Technische Mitteilung / technical information (service bulletin)**Nummer / No. FK14 # 02-2009**

Muster/model: FK 14
Baureihe/ type: B + B2 serial number # 035 - 096
Betreff/subject: Einbau der Kraftstofffilter / installation (position) fuel filter
gültig ab/valid from: sofort/ with immediate effect
gültig für/valid for: Produktion/manufacture Wartung/maintenance

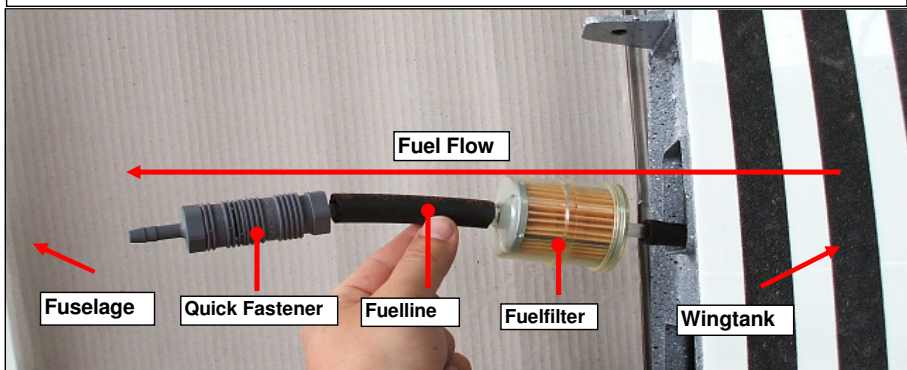
Beschreibung/description: Unterbrechung der Benzinversorgung durch verschmutzte Schnellverschlüsse / Interruption of fuel flow by conterminated quick fasteners

Falls ein Kraftstoff Schnellverschluss montiert ist, muss in Flussrichtung gesehen zuerst der Benzinfilter und dann der Schnellverschluss montiert werden. Dadurch werden Schmutzpartikel und Fremdstoffe im Filter zurückgehalten und können den Schnellverschluss nicht verstopfen. **Diese Überprüfung / Änderung ist an beiden Flächen durchzuführen!**

If a fuel quick fastener is mounted, in fuel flow direction seen first the fuel filter and then the quick fastener must be mounted. Dirty particle and foreign matters are thereby held back in the filter and cannot block the quick fastener. **This inspection / modification is to be carried out in both wings!**
